1206 Staples Street NE

Case #21226

House Overview

SUBJECT: Proposed third story and rear addition to an existing single-family row dwelling, and conversion to a Two-Family Flat. Modifications to protected rooftop elements in the RF-1 Zone and a new roof deck.

Exhibit 1206 S.2 DECK-PLAN-REV3

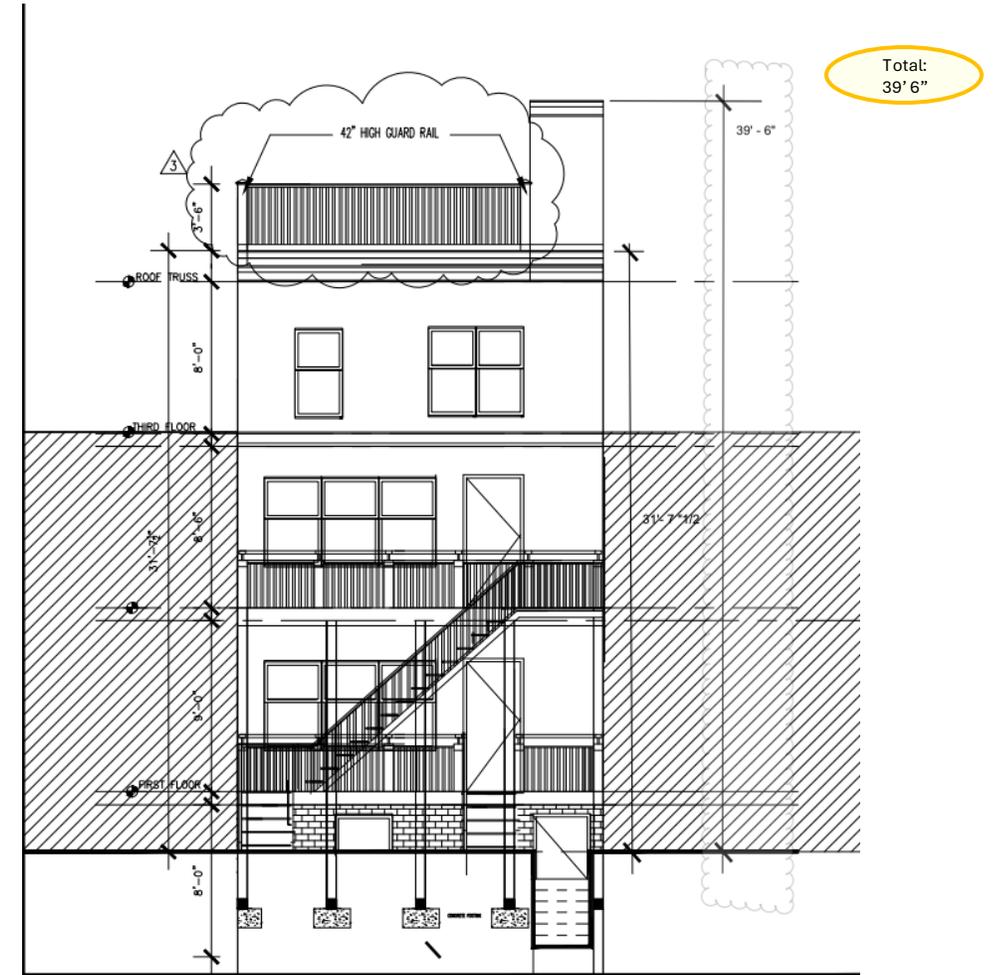
| # | Type | Relief | Pursuant To | Reason |
|----|-------------------|---|---|---|
| 01 | Special Exception | The penthouse uses requirements of Subtitle C § 1501.1(b) | Subtitle C § 1501.1(c) and Subtitle X § 901.2 | Proposed rooftop structure exceeds the maximum allowable height in the RF-1 Zone. |

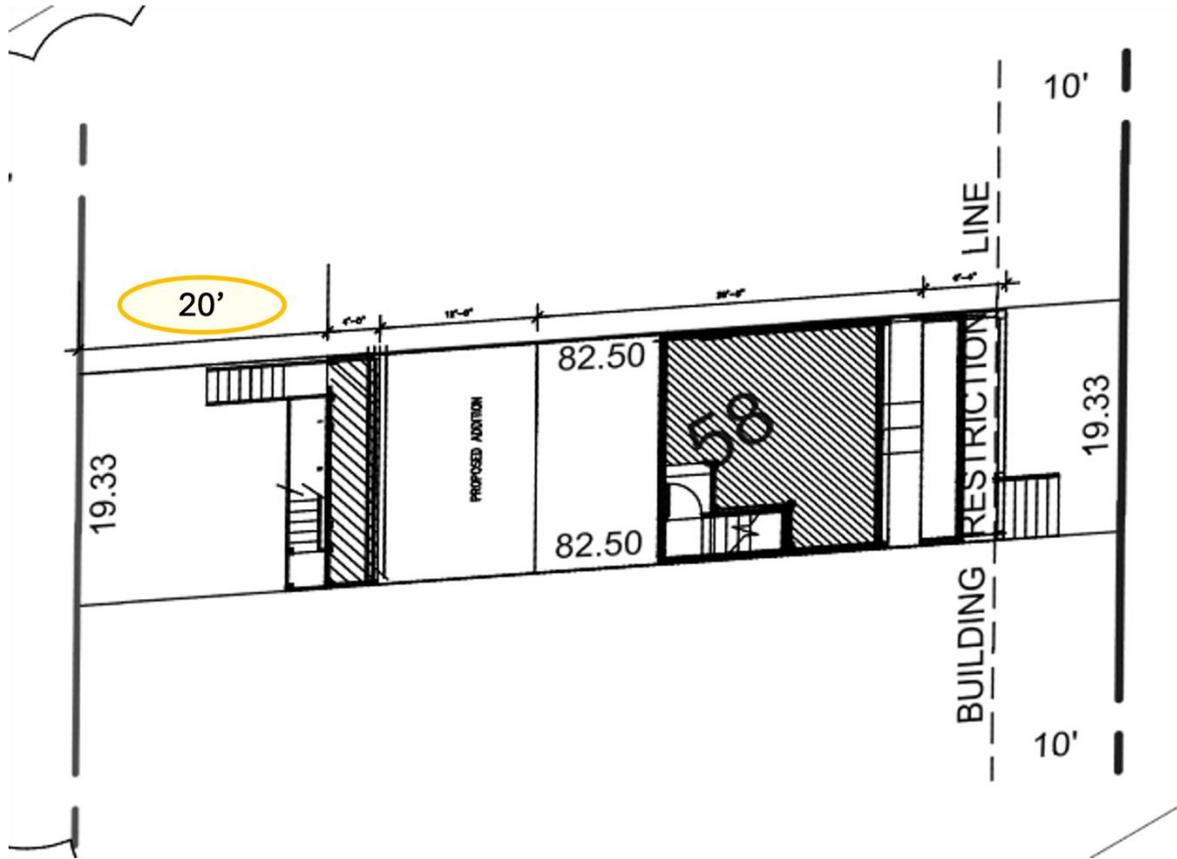
| # | Type | Relief | Pursuant To | Reason |
|----|-------------------|--|--|---|
| 04 | Special Exception | The rear yard requirements of Subtitle E § 207.1 | Subtitle E § 5201 and Subtitle X § 901.2 | Proposed rear setback is less than the 20'-0" required setback for the RF-1 Zone. |

Rationale: We comply with the zoning rule. We utilized the DC Survey Plat and measure a 20-foot setback. The surveying system used by Zoning cannot match the values.

Further detailed in Exhibit 5

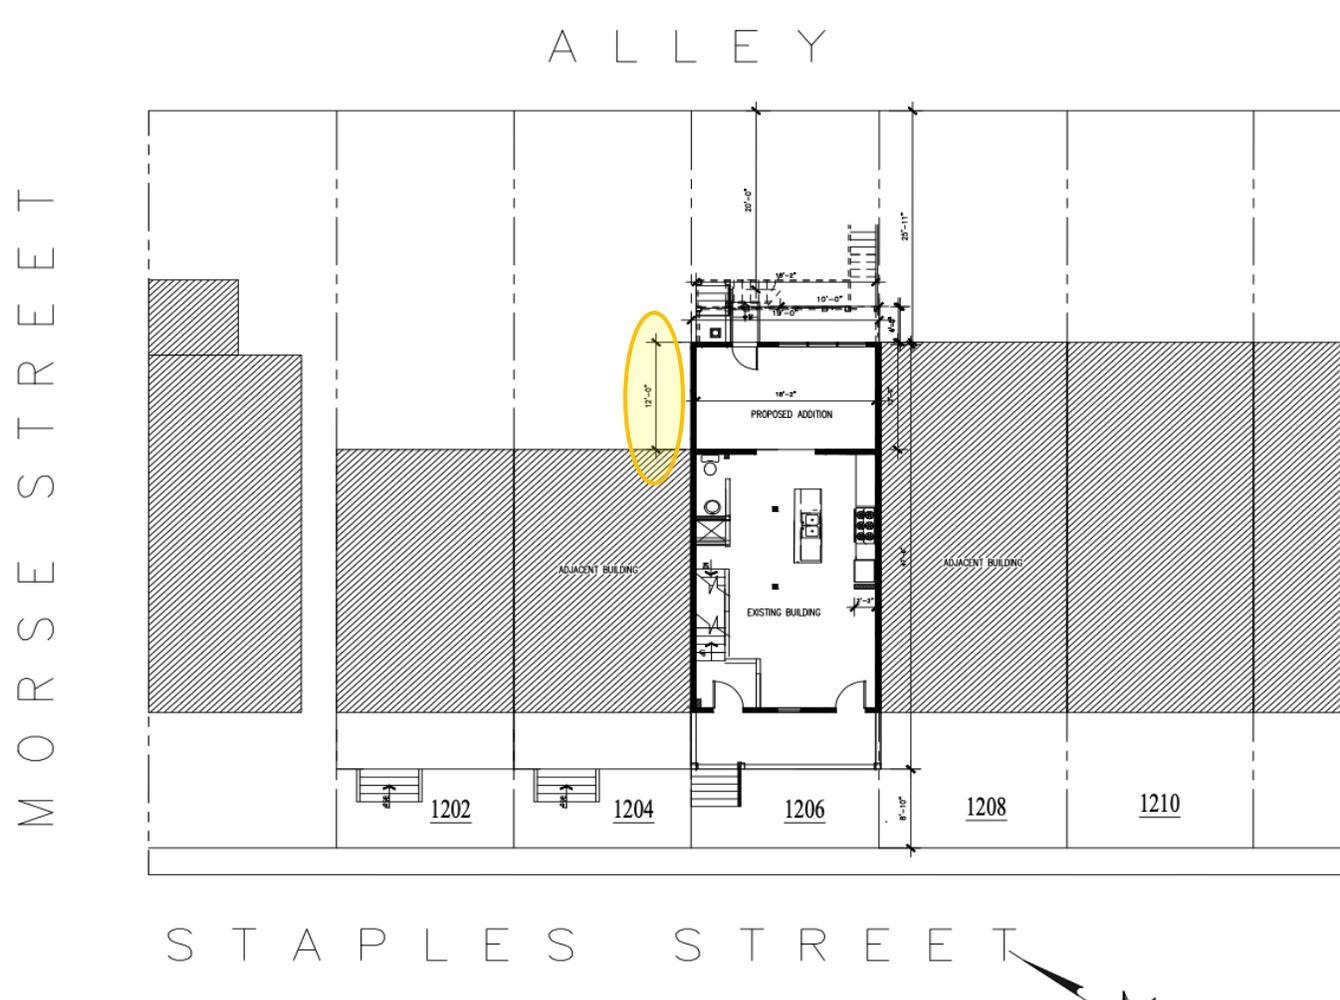
| # | Type | Relief | Pursuant To | Reason |
|----|-------------------|--|--|---|
| 05 | Special Exception | The rear addition requirements of Subtitle E § 207.5 | Subtitle E § 5201 and Subtitle X § 901.2 | Proposed rear addition is greater than the 10'-0" maximum beyond adjacent structures in the RF-1 Zone |
